Shop Drawing Submittal Review

Project Name: Webster University-**ISB**

Copies	No.	Description
1 PDF	221319P01	(Submittal No.'s)
		(Cannon #22 1319-002) - (Paric #15051-) – (WES #607)
		➢ **Sanitary Specialties Product Data:**
		• Wade Floor Drains: FD-1, FD-2, FD-3
		• Wade Floor Sinks: FS-1, FS-2
		• J.R. Smith Floor Sinl: FS-3
		• Wade Floor Cleanout: FCO-1
		• Wade Wall Cleanout: WCO-1, WCO-2

PROJECT NAME: Webster University ISB
LOCATION: St. Louis Missouri
CLIENT PROJ. NO.: N/A
WES PROJ. NO.: 607
SPEC SECTION: 22 1319 Sanitary Waste Piping Specialties
SUBMITTAL ITEM: See Below -

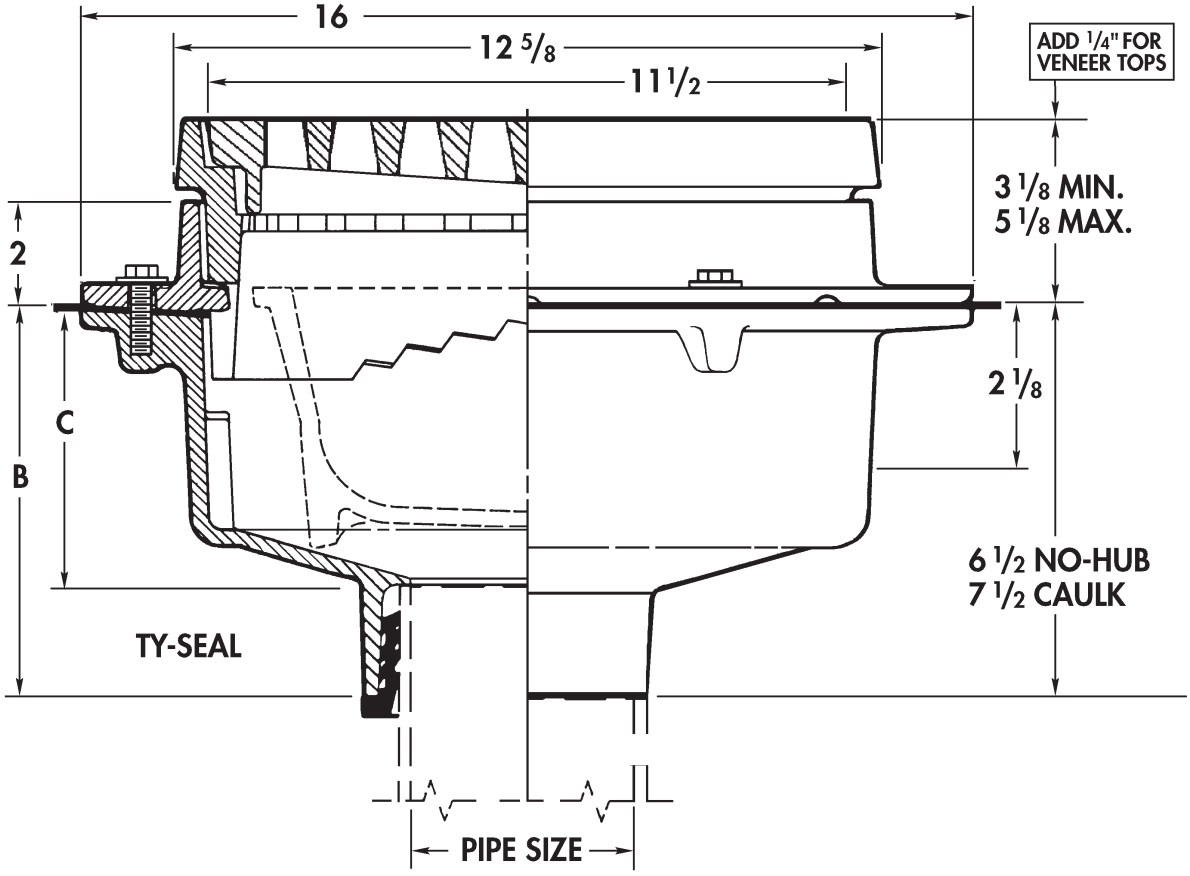
Specified to include trap guard seal device. Refer to drawing P0601, Addendum 2-4, dated 24 May 2016
